DESCRIPTIVE REPORT

DESCRIPTIVE REPORT  
to accompany  
HYDROGRAPHIC AND WIRE DRAG SHEET  
of  
WARM SPRING BAY

Report on Hydrographic Sheet No. 4595 (Including Wire Drag)

Warm Spring Bay, Southeast Alaska

Diagram indicating revolvers and weak fixes found on H-4595

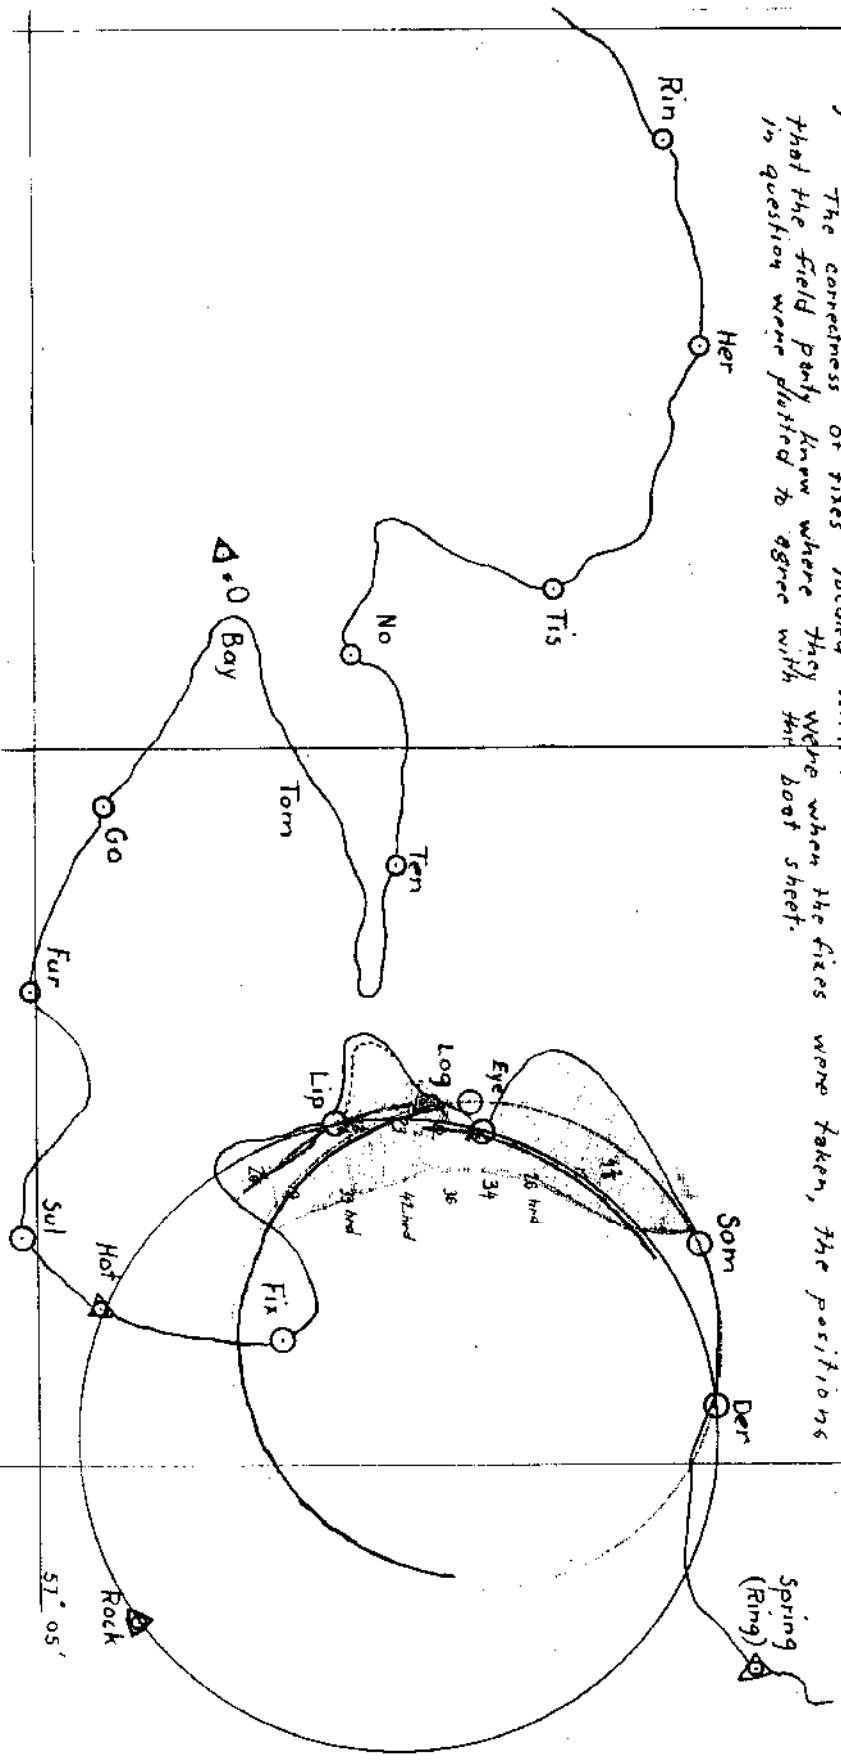
Fixes 1c, 2c, 6c and 7c are revolvers or weak fixes and the correctness of the immediate area surrounding them is doubtful. The positions in question were plotted to agree with the boat sheet, it being assumed that the field party knew approximately where they were when the fixes were taken. A diagram with the above revolvers indicated and the doubtful area shaded is attached to the ~~smooth sheet~~. *descriptive report.*

Fix 1c whose signals are Der, Som and Log may be plotted anywhere on the green line shown in diagram.

Fix 6c, also with signals Der, Som, & Log may be plotted anywhere on the black line shown in diagram. Like was Fix 7c with same signals may be plotted anywhere on the blue line shown on the diagram.

A circle through signals Der, Lip & Rock is shown in brown.

Fix 2c with signals Der, Lip, & Rock may be plotted anywhere on the red line shown on diagram.

Fix 7c with signals Der, Som & Log may be plotted anywhere on the blue line shown on diagram.

Remarks: Circles were passed through the above signals in order to ascertain just how much of a revolver the fixes in question were. The correctness of fixes located within the shaded area is doubtful. Assuming that the field party knew where they were when the fixes were taken, the positions in question were plotted to agree with the best sheet.
